New Era Fashions Mfrs (BD) Ltd

Plot 10,11 & 12
Sector 8, Road 3, CEPZ, Chittagong
(22.279298N, 91.776438E)

21st June 2014

Observations

Water Ingress

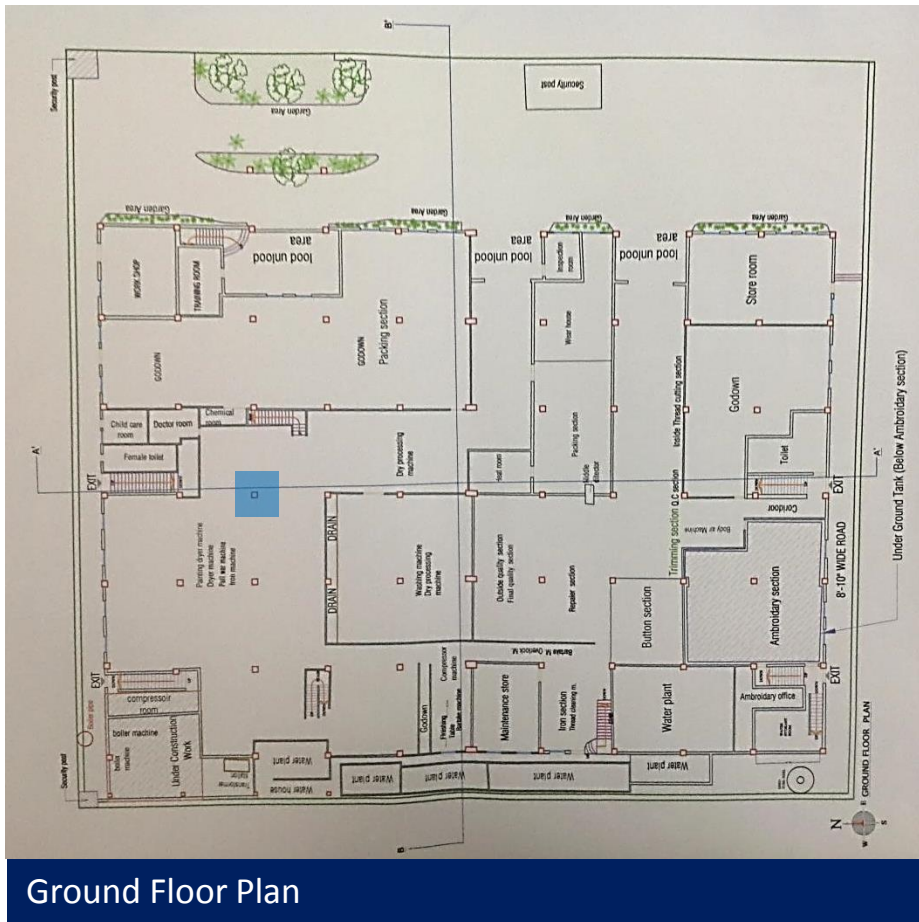
Safety Hazard – Water ingress through unsealed expansion joint adjacent to electrical panels

Expansion joint has not been waterproofed resulting in water ingress at 1st Floor level. There are serious concerns over the proximity of electrical panels adjacent to the joint.

Water ingress penetrating construction joints where electrical panels are connected

Water ingress at expansion joint

Collected water in a pail during heavy rainfall

Item No.	Observation	Recommended Action Plan	Recommended Timeline
1	Safety hazard – Water ingress through unsealed expansion joint adjacent to electrical panels	Building Engineer to advise on adequate waterproofing of expansion joint and to supervise works with immediate effect.	Immediate - Now
2	Building columns appear to be stressed in excess of normal design limits	Building Engineer to review design, loads and column stresses in building.	6-weeks
3	Building columns appear to be stressed in excess of normal design limits	Verify insitu concrete stresses either by 100mm diameter cores or existing cylinder strength data for cores from min. 4 columns.	6-weeks
4	Building columns appear to be stressed in excess of normal design limits	Verify existing reinforcement in columns.	6-weeks
5	Building columns appear to be stressed in excess of normal design limits	Produce and actively manage a loading plan for all floor plates within the factory, giving consideration to floor capacity and column capacity.	6-months

Ground Floor Plan

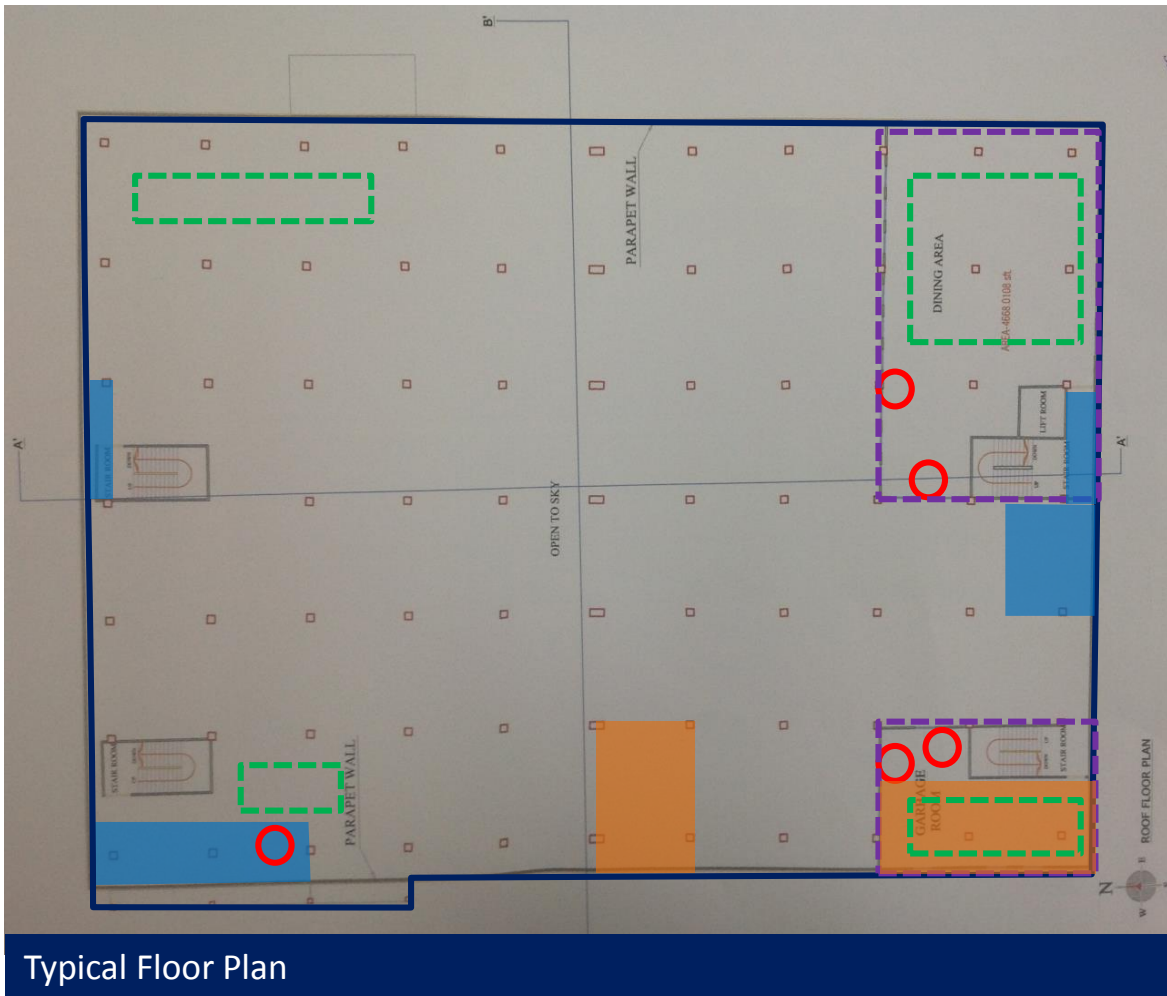
**Building columns appear to be stressed in
excess of normal design limits**

Cursory calculations indicate that the working stresses of the columns at Ground Floor level are above normal design limits.

Tested Column

Stone Aggregate

12 no. high yield rebar

Building footprint

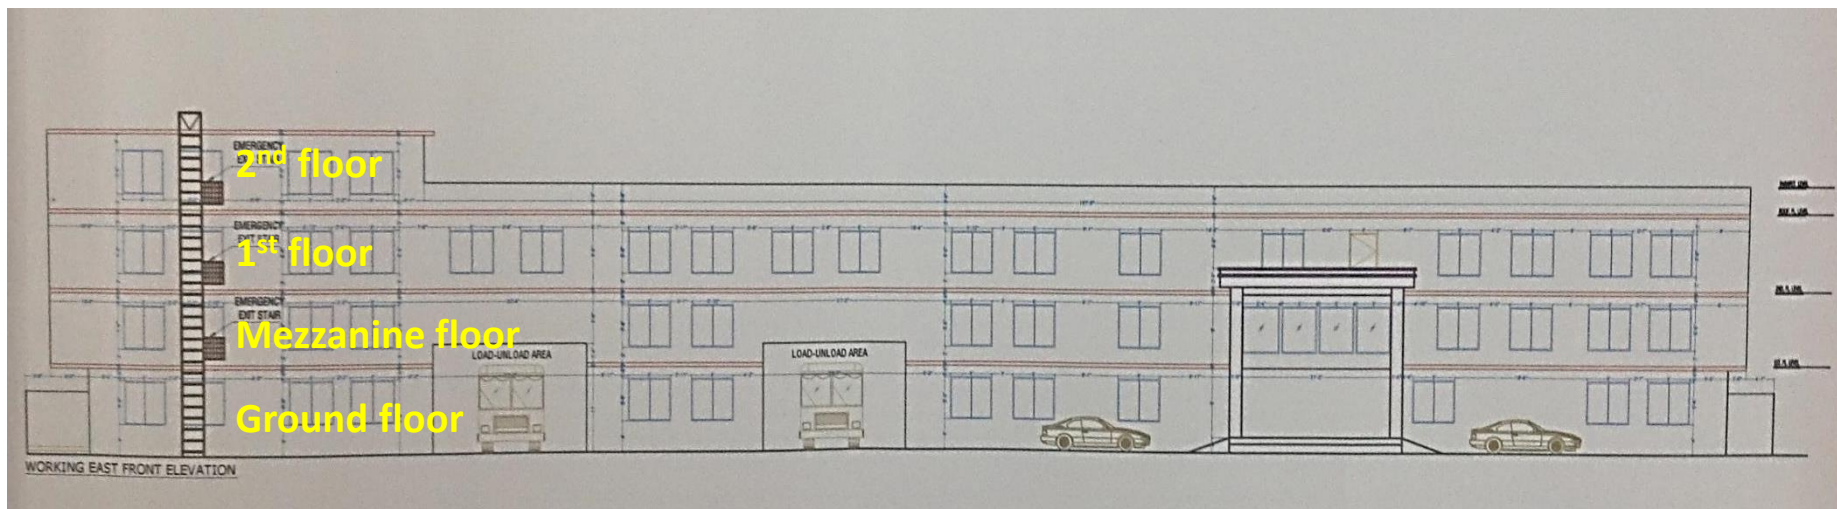
Heavy floor loading and lack of a Loading Plan

Areas of high loading were observed in the building, including Gazi water tanks and construction material storage at Roof level, fabric and boxed storage at 1st and Mezzanine Floor levels, and significant toilet build-up at 1st and Mezzanine floor levels. There was no loading plan for the factory building available on the day of the survey.

Gazi water tanks at Roof level
(above 1st and 2nd Floor levels –
3,000 to 10,000 litres capacity)

Construction materials at roof
level

Fabric / boxed storage at 1st and
Mezzanine floor levels

Toilets with significant floor
build-up at 1st and Mezzanine
Floor levels

3,000 litre & 5,000 litre water tanks on roof (2nd Floor)

2 No. 10,000 litre water tanks on roof (2nd Floor)

Toilet floor build-up (430mm average)

Construction materials on roof (2nd Floor)

Storage room on Mezzanine floor

Storage room on 1st floor

Item No.	Observation	Recommended Action Plan	Recommended Timeline
6	Heavy floor loading and lack of a Loading Plan	Building Engineer to carry out a design check of floor slabs for loads associated with the water tanks, toilet build-ups and storage areas, and to advise on any necessary alterations taking account of floor capacity.	6-weeks
7	Heavy floor loading and lack of a Loading Plan	Factory Management to actively implement and manage Loading Plan.	6-months
8	Irregularities in documentation requiring clarification	Building Engineer to survey all areas of the building, collect information and prepare a full and accurate set of “as-constructed” drawings.	6-weeks
9	Irregularities in documentation requiring clarification	Building Engineer to review foundation design in relation to allowable bearing pressure.	6-weeks
10	Lightweight, non-engineered roof structures	Building Engineer to review the design of the lightweight roof structures regarding their ability to withstand wind loading pressure, suction and uplift forces, with special emphasis on connections and bracing.	6-months

Drawing Inconsistencies

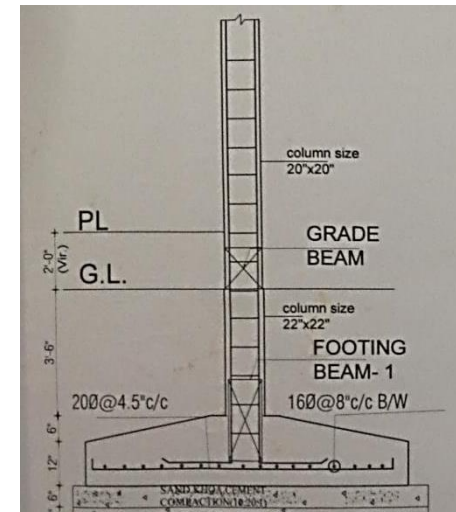
- The soil test report recommended a raft foundation for a structure greater than 3 storeys. The building is 4 storeys inclusive of Mezzanine floor, but the drawings show strip footing foundations. While there are no obvious signs of foundation settlement, cursory calculations indicate that the recommended pressures are being exceeded.
- The structural drawings indicate that all internal columns should have 14 reinforcement bars, whereas only 12 were observed using the Ferro-scanner.
- Flat slab construction was observed over a section of the Mezzanine Floor, while the drawings indicate beam and slab construction throughout.
- Toilet areas with significant floor build-up are larger than indicated on the design drawings.

East elevation showing a 3 storey building plus one Mezzanine Floor level (total of 4 storeys)

Foundation type recommendations (extract from Soil Test Report):
For structures greater than 3 storeys a raft foundation is recommended

Strip foundation

Drawing Inconsistencies

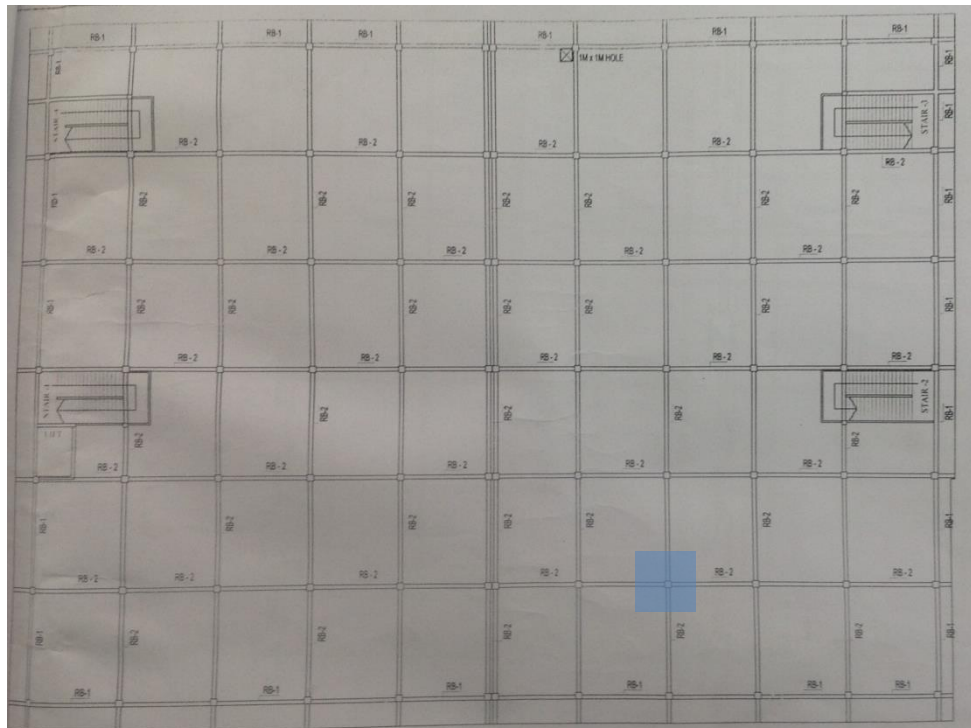
Column layout highlighting extent of internal column C4

12 no. bars observed in internal column C4 at Roof level and confirmed at Ground Floor level using the Ferro-scanner

14 no. bars shown on drawings for column C4
